SUMMARY OF SUBMISSIONS
Proposed Outbuilding – Lot 7, 25 Turner Street, Serpentine PA21/28

SUMMARY OF SUBMISSIONS
Proposed Outbuilding – Lot 7, 25 Turner Street, Serpentine PA21/28

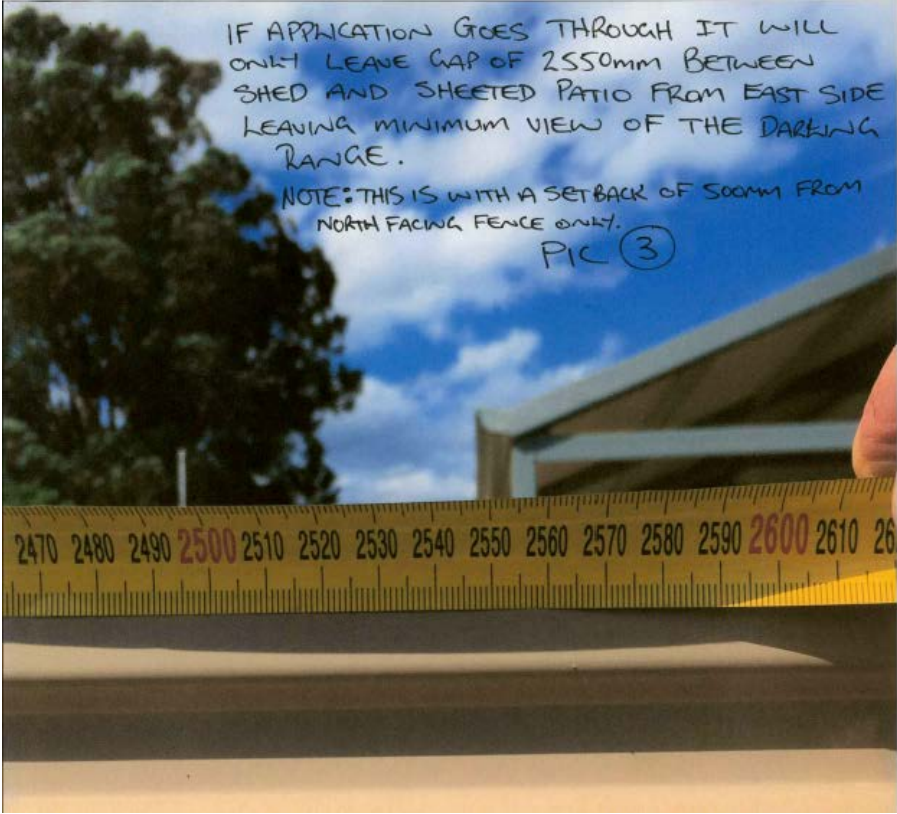
Submitter	No	Submitter Comments	Officer Comment
		 <p>WITH THIS DEVELOPMENT APPLICATION WE WILL LOSE THE ENTIRE VIEW OF THE DARLING RANGE, WHICH WAS A MAJOR DRAW CARD TO BUY THIS LAND AND BUILD OUR HOME ON.</p> <p>Pic ①</p> <p>9m</p> <p>4.08m</p> <p>4.08m</p> <p><small>Content Manager - Registered - Kwinana - Friday, 10 March 2021</small></p>
